HR Green Reponses

Flying Horse North
Master Development Drainage Plan

Revised: July 28, 2022

PCD File No. SKP223

SHEET SP.2

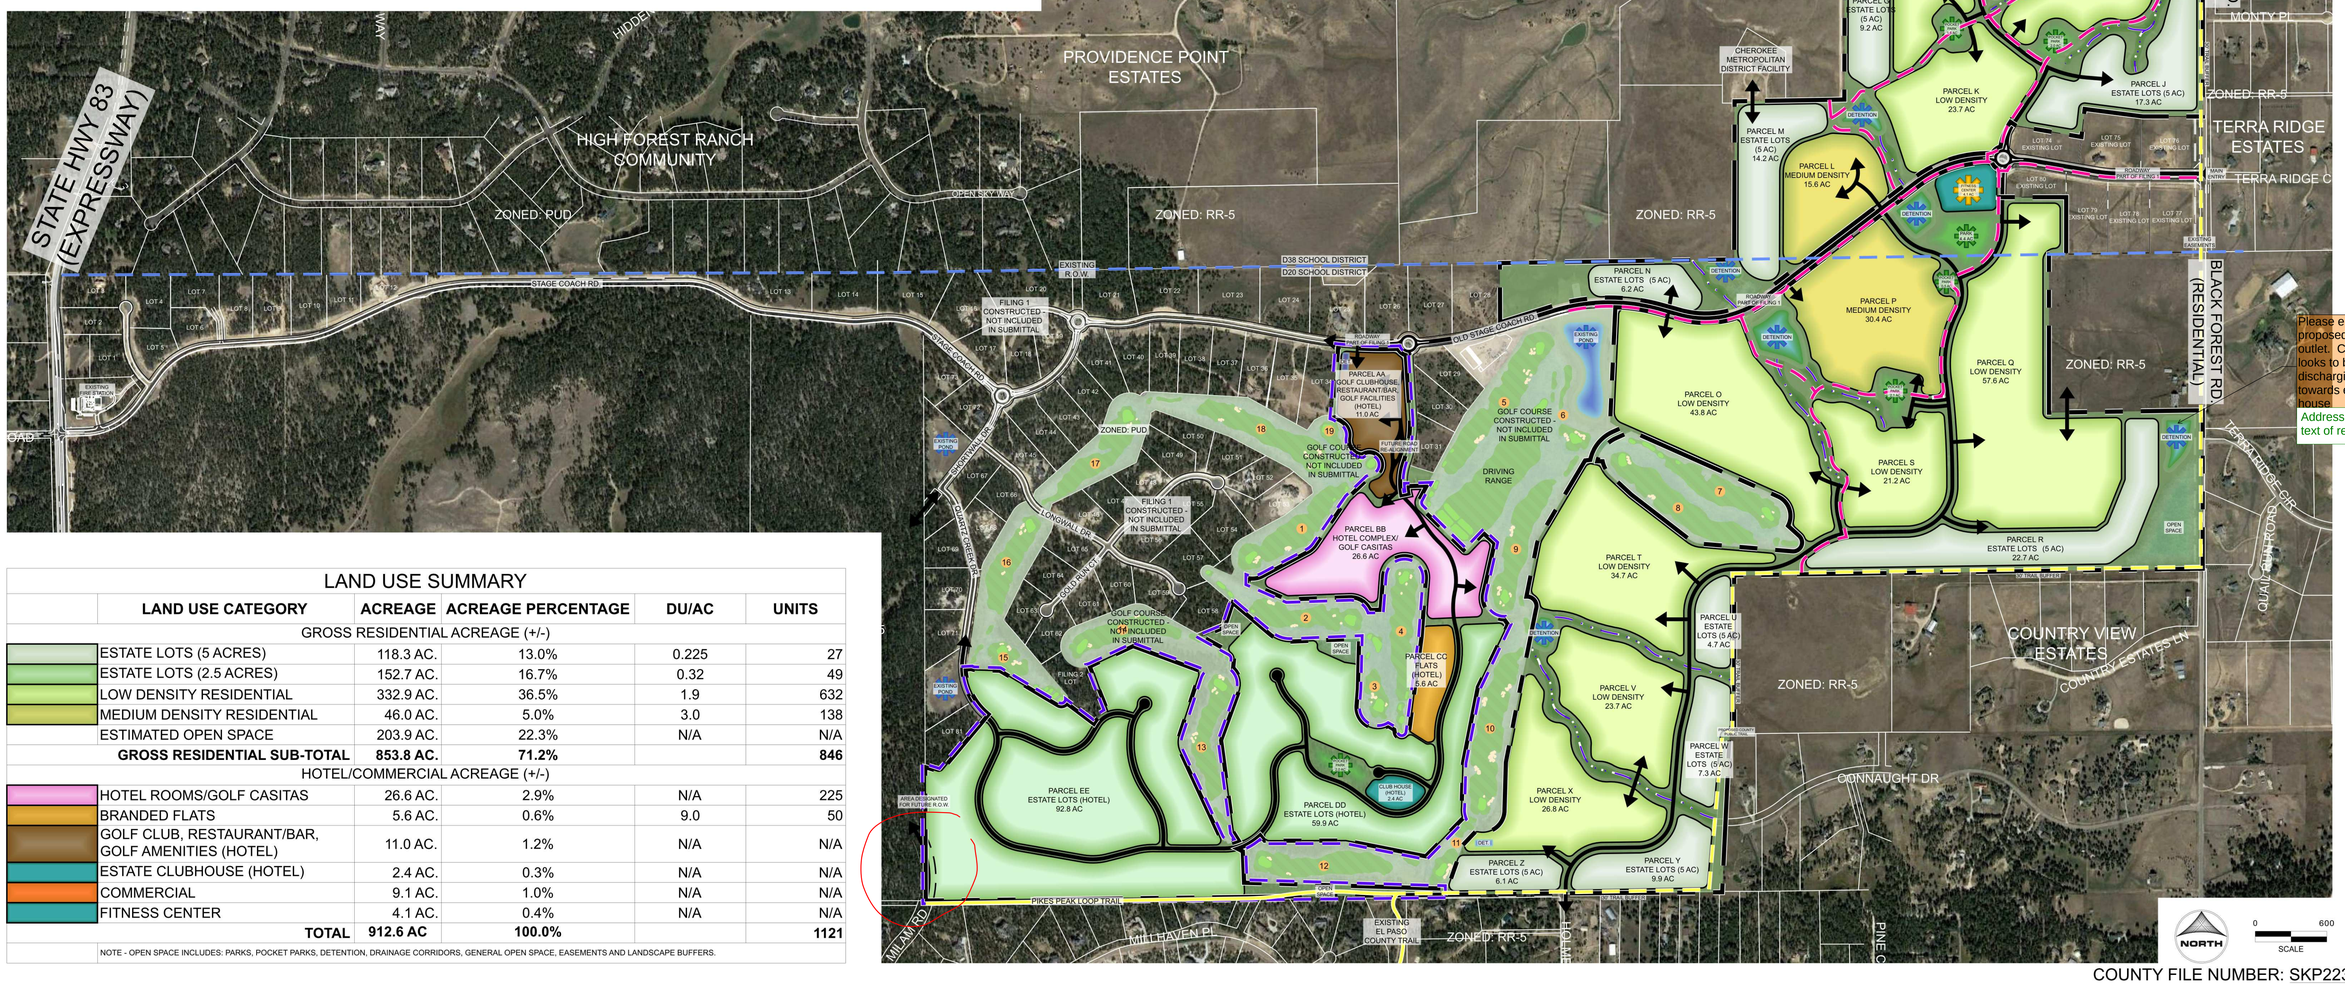
Please elaborate on proposed Pond 9 outlet. Currently looks to be discharging directly towards existing house.

Addressed in text of report
